Request for Additional Information: Section 117(3) of the Maritime Area Planning Act 2021

**Re: EirGrid plc
Maritime Usage Licence Application Reference: MUL240010**

The GIS files re submitted (06.01.2026) have area '**Area A**' drawn, which correspond to the Map Title: "**Proposed MUL Map**", Rev: P06 which depicts the area of site investigation works to inform the engineering design and environmental assessments of a proposed electrical cable circuit crossing Dublin Bay from Blackrock Park to Shellybanks.

Image 1: Resubmitted GIS data – 06.01.2026

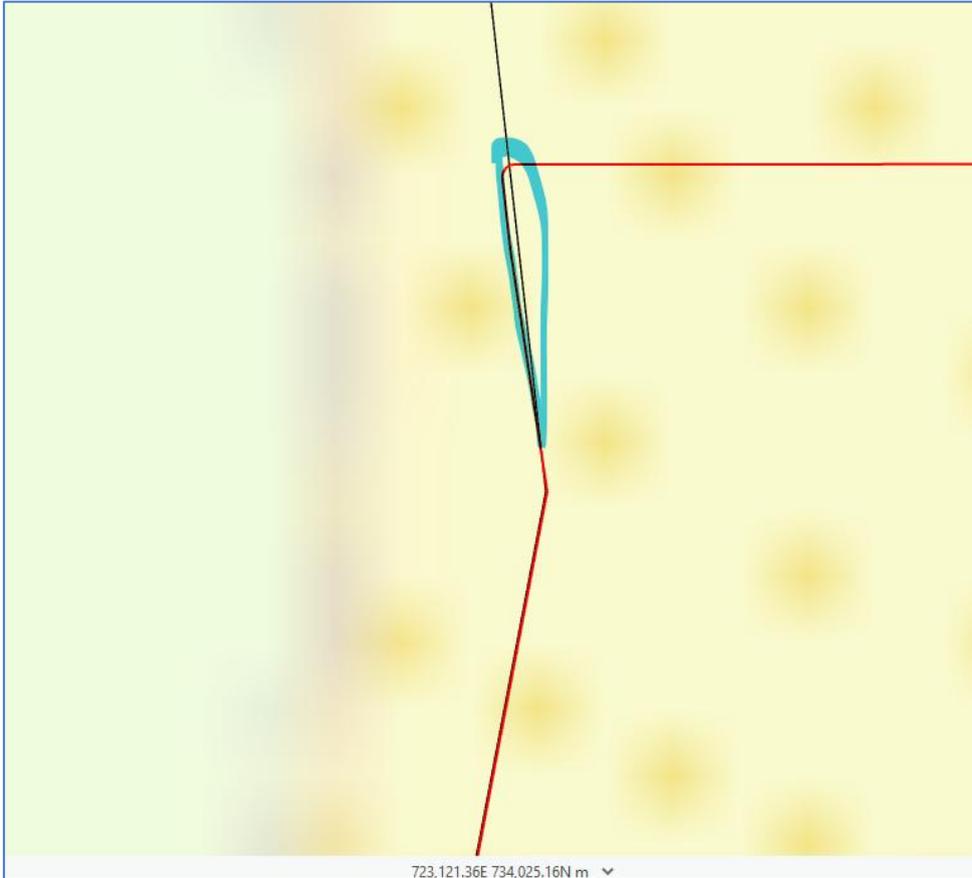
- ii. Where the MUL area abuts the land, the boundary of the MUL area should coincide with and follow exactly the High Water Mark as defined by the Chief Boundary and not **traverse into terrestrial land**. See Image 1 example.
 1. Tailte Eireann 'High Water Mark - National Water Marks - Ungeneralised – 2024' dataset from the Surveying Open Data Portal (<https://arcg.is/1P1yDS>).

Image 2: Resubmitted GIS data – 06.01.2026

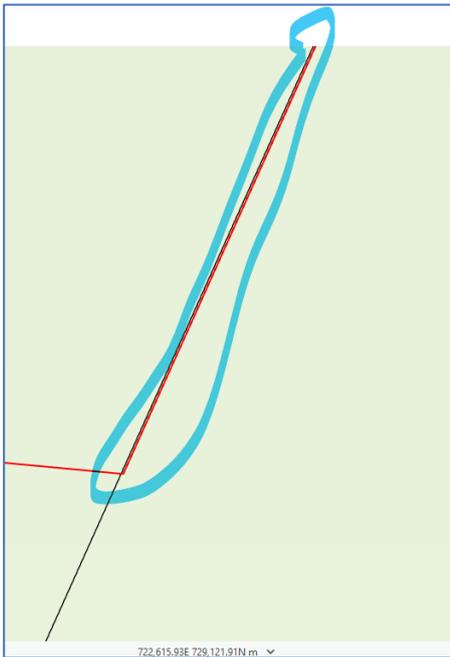
There is evidence that the resubmitted GIS data (06/01/2026) has been edited in places. However, at a number of locations, the slight shift to the right within the GIS dataset remains. This shift has caused the proposed MUL boundary dataset to traverse onto terrestrial land. See Images examples 2 and 3 below.

3. Please ensure that the GIS data files are updated accordingly and resubmitted to MARA.
 - a. Adhere to the **MARA Technical Mapping Guidance Note for MAC/MUL Applications**: https://www.maritimeregulator.ie/wp-content/uploads/2025/09/MARA_Technical_Mapping_Guidance_for_MAC_MUL_Applications.pdf
